TOLEDO - LUCAS COUNTY PLAN COMMISSIONS

REF: SPR-10-21

TO: President Matt Cherry and Members of Council, City of Toledo
FROM: Toledo City Plan Commission, Thomas C. Gibbons, Secretary
SUBJECT: Request for a Site Plan Review for new building with waiver

Request	-	Major Site Plan Review for new building with waiver
Location	-	0 South St. Clair Street
Applicant	-	Toledo Federation of Teachers 4427 Talmadge Road, Suite A Toledo, OH 43623
Architect	-	Julie Apt, Thomas Porter Architects 8 North St. Clair Street Toledo, OH 43604

South & East Elevations

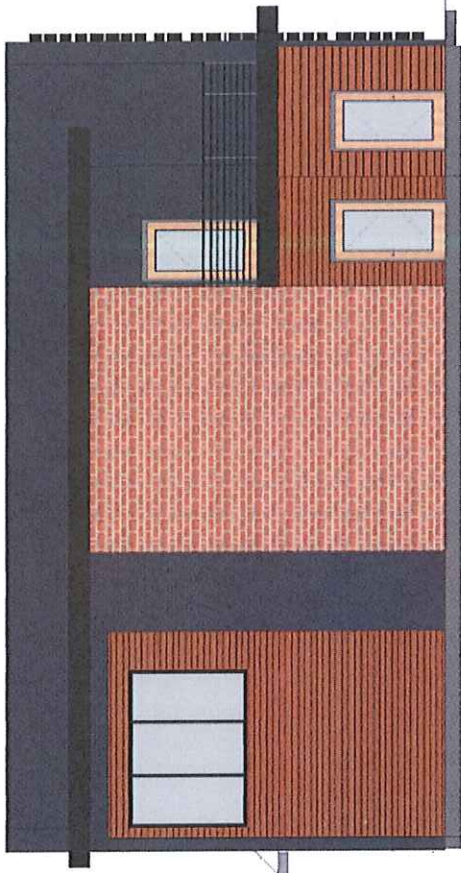
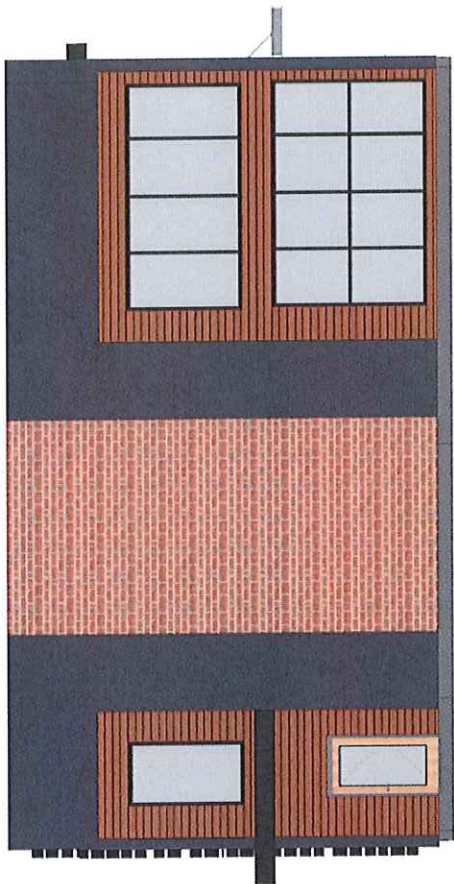
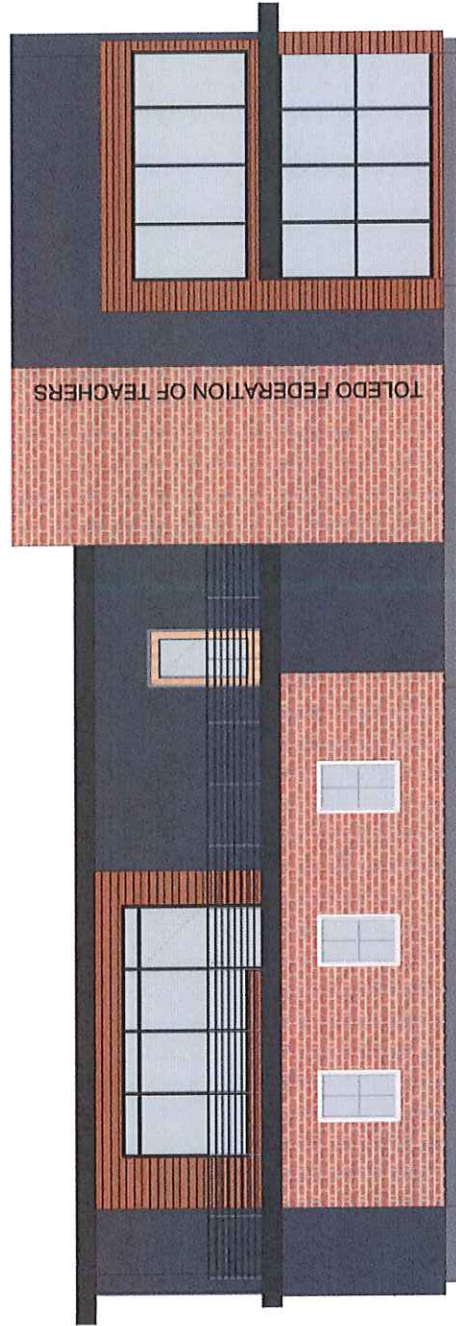
Based on the overall layout of the site, all sides of the buildings shall be subject to the façade material standards as listed in TMC§1109.0502 Requirements Matrix. For façades visible from the public right-of-way, predominant exterior materials must comprise at least eighty percent (80%) of the total wall area of the façade. Exterior building materials include brick, architectural metal, wood, stone, glass, stucco, and materials with a brick-like appearance or similar material. Under the building material matrix for accent building materials, up to 20% of each elevation may be comprised of stucco, wood, architectural concrete masonry units, fiber cement board, EIFS, ceramic, vinyl or composite siding or glass block. As presented on the elevations, fiber cement board siding accounts for approximately 16% of the façade facing South St Clair Street, 19.5% facing River West apartments, 24.5% facing Lafayette and 14.7% of the façade facing Summit Street. The primary building materials composing the balance of materials to be used include: 31.9% brick, 19.3% glass, and 30.7% architectural panels and are compliant with City regulations.

34. The building design shall meet the requirements of TMC§1109.0502 *Building Façade Materials and Color Requirements*. Building material standards apply to all facades that are visible from the right-of-way. Percentages apply to each façade individually. Under the building material matrix up to 20% of each elevation may be comprised of stucco, wood, architectural concrete masonry units, fiber cement board, EIFS, ceramic, vinyl or composite siding or glass block; As presented on the elevations, fiber cement board accounts for approximately 18.1%; **acceptable as indicated on building elevations.**
